re: **Grading Plan Review**
Proposed Residential Development
Trails Edge West – Block 140 - Ottawa, Ontario

file: PG6406-MEMO.01 Revision 1

Grading Plan Review

Title
GRADING PLAN

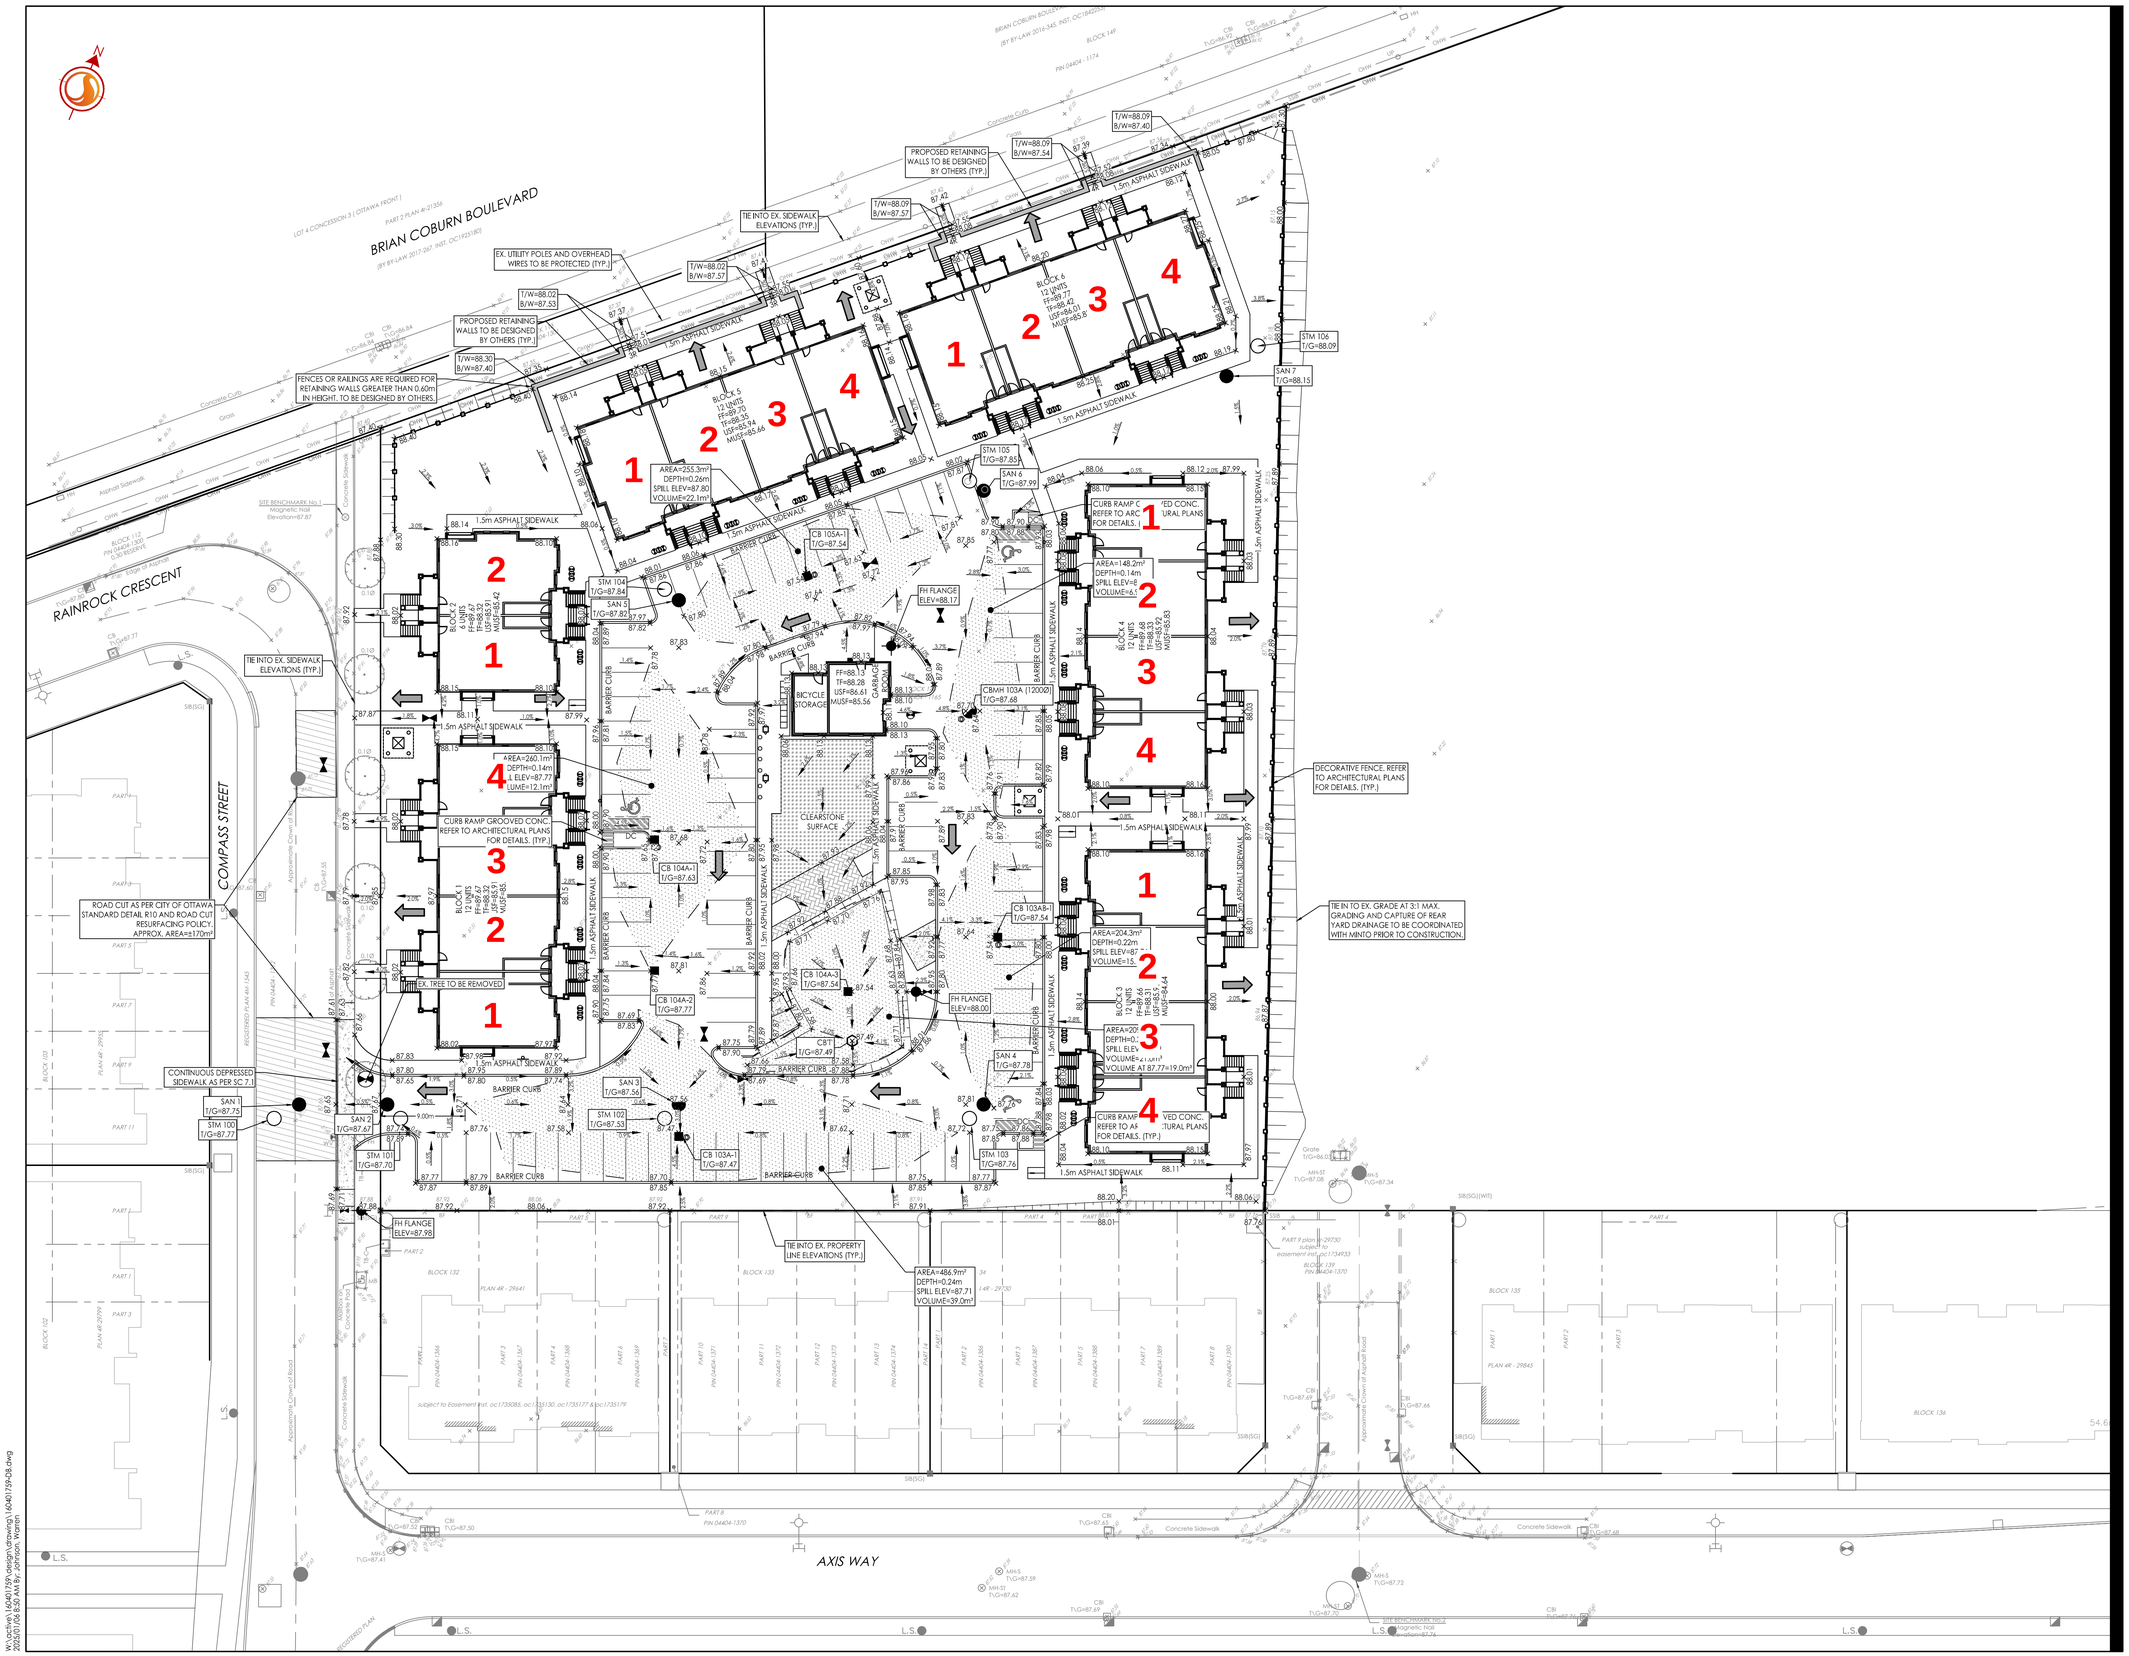
The lot-by-lot grading summary is provided on the attached Table 1. Based on the grading plans provided, the proposed grading does, at a small number of units, marginally exceed the permissible grade raise recommendations provided in the above-referenced Geotechnical Investigation Report. Therefore, lightweight fill (LWF) is recommended below the garage (if applicable) and front porch of the subject units.
